SERVICE INFORMATION

Number: 987-1585 UTG. 2

Error in fitting instructions 75 02 24 for the Saab compact heater

Saab 900 M94-.

Wiring diagram

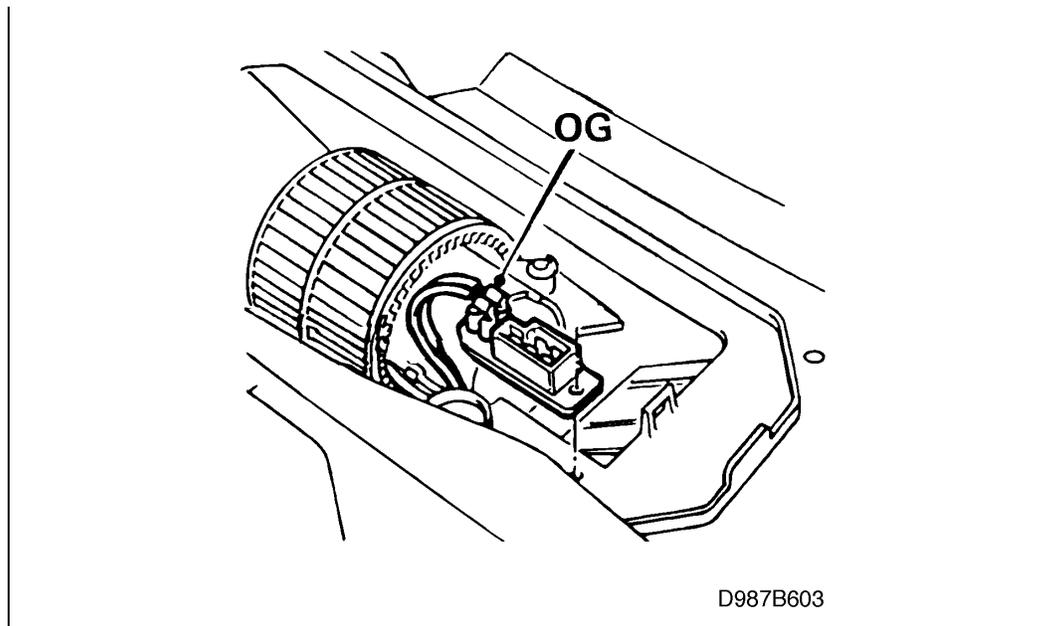
In point 39 of the fitting instructions, the colours of the leads in the diagram are labelled incorrectly. The text is correct.

Cars on which installation has been carried out as described in edition 1 must be rectified in accordance with this edition.

The orange lead mentioned in point 39 of the fitting instructions is connected between the motor and the plate with the 5- pin connector.
